Tarheel Lodging
Written Narrative and
Proposed Plan and COA Modifications (Buildings 3/4 and 5)

August 23, 2022
Updated August 30, 2022

Having recently completed a portion of the Phase-I TRU Hotel development, The developer is requesting a modification to the current Certificate of Appropriateness (COA) to incorporate minor changes to the multi-family building including updated floor plans. The following is a listing of proposed modifications to the plans including some previously approved Design Alternates.

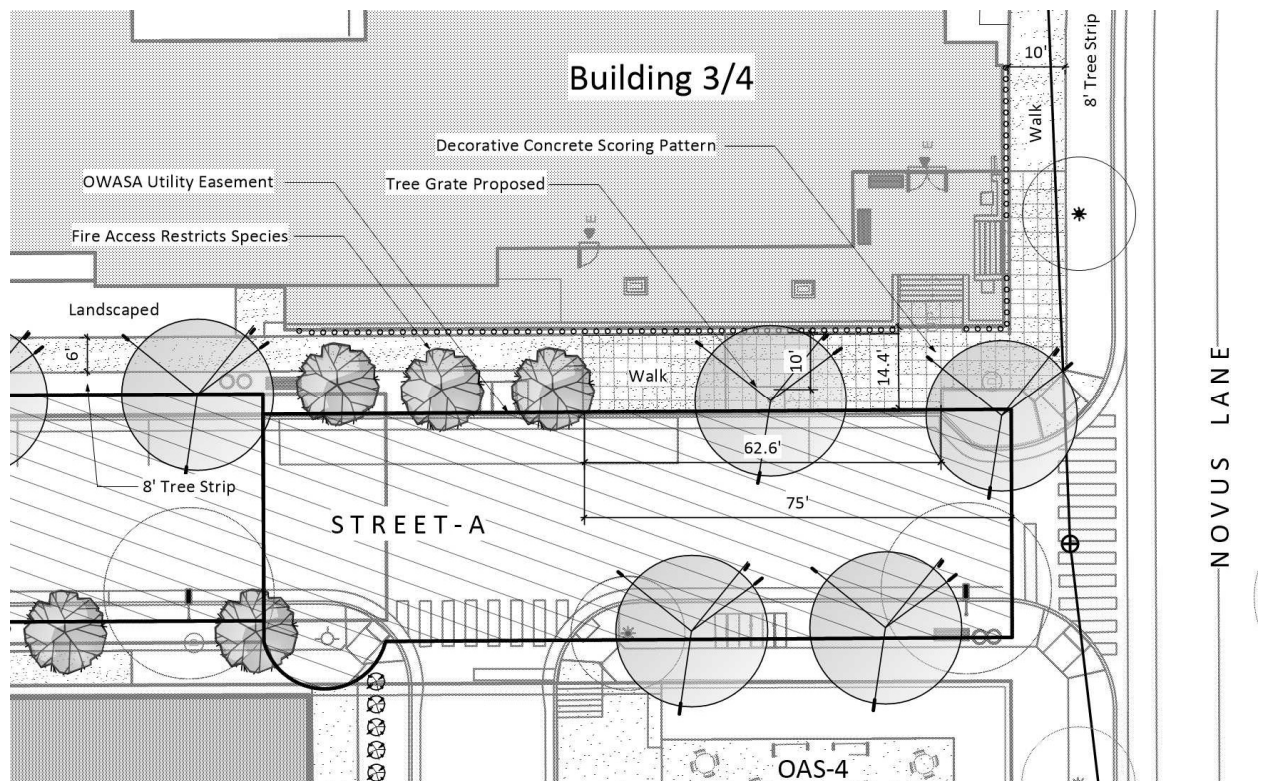
5. Transformer located within 10 ft of sidewalk on Street-A garage entrance with architectural screening proposed.

Justification: Duke Energy's requirements for separation from doorways and windows combine to leave no other alternative for alternate locations.

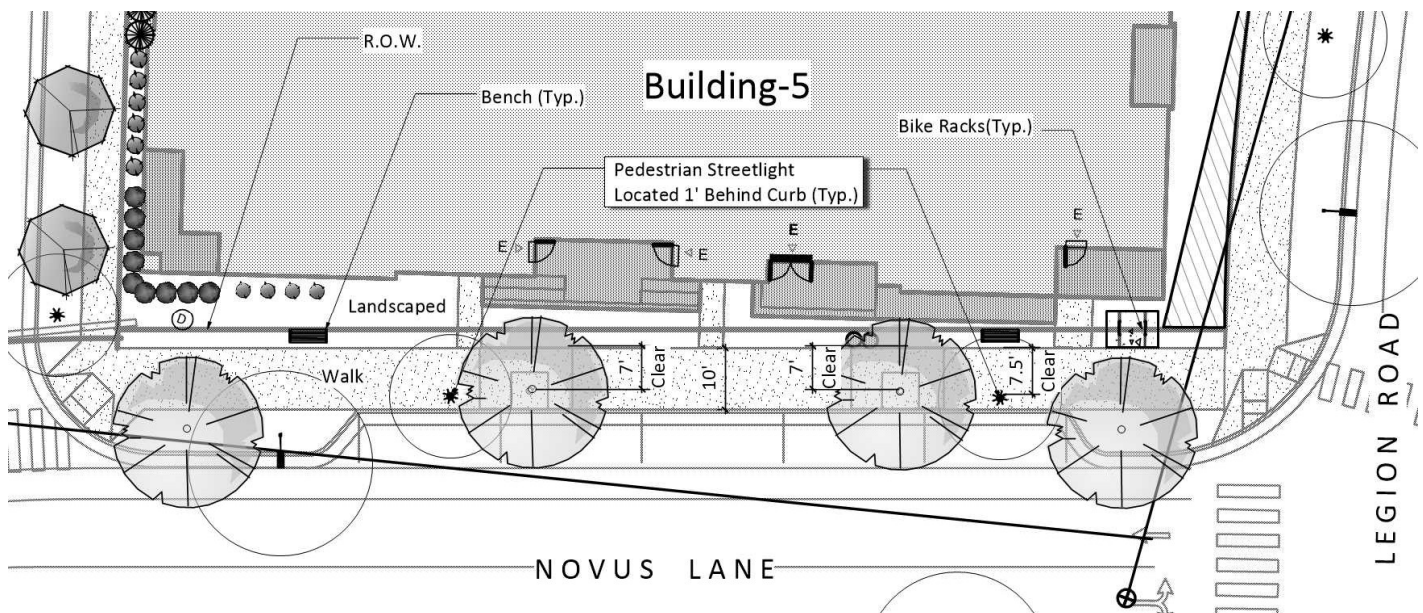
2. **Design Alternate-16** Sidewalk requirements along Novus Lane (Type-A Frontage) is 10 ft + 8 ft tree strip. Sidewalk is proposed to be located adjacent to BOC at Building-5 Frontage with two tree pits and grates integrated into sidewalk area.

Justification: Minimum sidewalk width of 10 ft is maintained except at two tree grates where it is reduced to 6.5 ft. This condition is adequate for the anticipated residential pedestrian traffic (consistent with a Type-A3 Frontage width) but does not meet the Type-A1 requirement of 10 ft. Additional concrete area can be added in a bulbed-out configuration but the aesthetic would suffer, additional impervious surface added and we do not feel it is justified due to the residential pedestrian traffic anticipated.
